Service Information

Model: GP605 Ref. No.: FF-T01-K1-000024-01

Subject: UPDATING THE DESCRIPTIONS (FY8-13FD-000)

Reason: The contents of the Service Manual (FY8-13FD-000) has been updated to reflect additions and

Figure 9-403

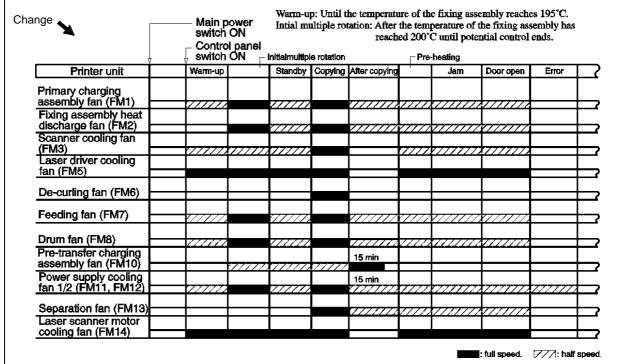
9-9 2. Sequence of Operations

The fans operate as follows, ones controlled according to the state of the printer and ones controlled by the state of the scanning lamp:

(FM3, FM4, FM11, and FM12 operate based on the state of both the printer unit and the scanning lamp, and the control mechanism for higher speed is used for the chart.)

a. Fans Operating According to the State of the Printer Unit

Figure 9-404

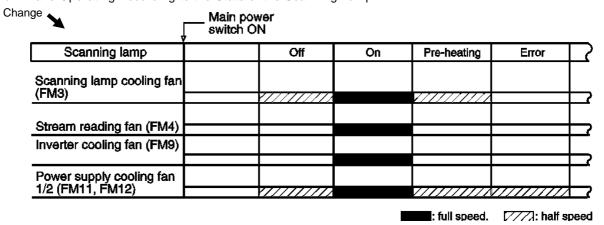
b. Fans Operating According to the State of the Scanning Lamp

(Figure 13-706)

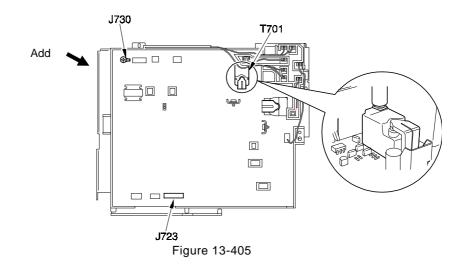
- 13-158
- 5) Turn on the PCB, and start the copier service support tool.
- 6) Connect the copier's power plug to the power outlet, and turn on the main power switch; then, turn on the control panel power switch.
- b. Downloading
- 1) When the copier service support tool has started, select 'To Main Menu' on the screen.
- 2) Select 'Next' under 'Download/Upload'.

3) Select the model and PCB for downloading.

IP: DIMM for IP-CPU MFC: DIMM for MFC

- 4) Start downloading for the flash ROM as instructed on the screen of the PC.
- 5) When downloading has ended, turn off the PC as follows:
- Press 'OK' \rightarrow 'return to PCB selection menu' \rightarrow 'OK' \rightarrow 'return to main menu' \rightarrow 'end service support tool' \rightarrow 'end'.
